Product / Process Change Notification

N° 2020-176-A

Capacity expansion with introduction of an additional assembly and final test location at Huayi Microelectronics Co., Ltd (HYME), China for dedicated TO220 3L MOSFET products in Gen 5.X/7.X/10.X

Marking on device:

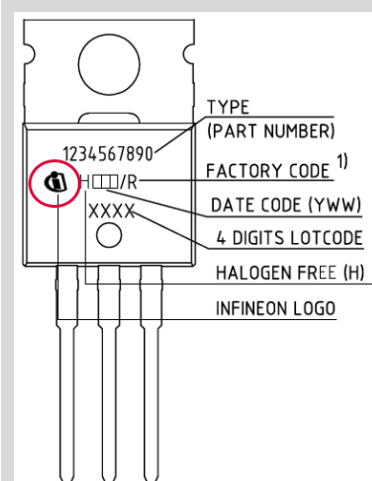
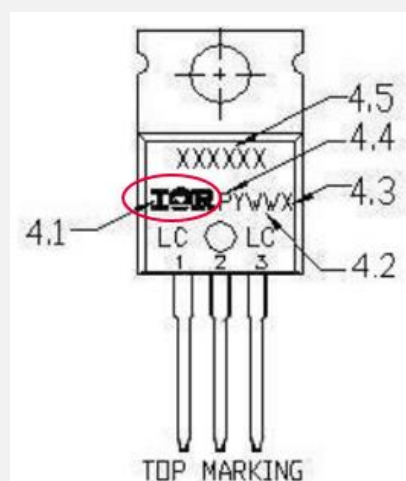
| <ul style="list-style-type: none">■ Legacy International Rectifier (IR) logo | <ul style="list-style-type: none">■ Legacy Infineon logo <p>Note: Existing there are slight variations in the marking layout across different production site.</p> |
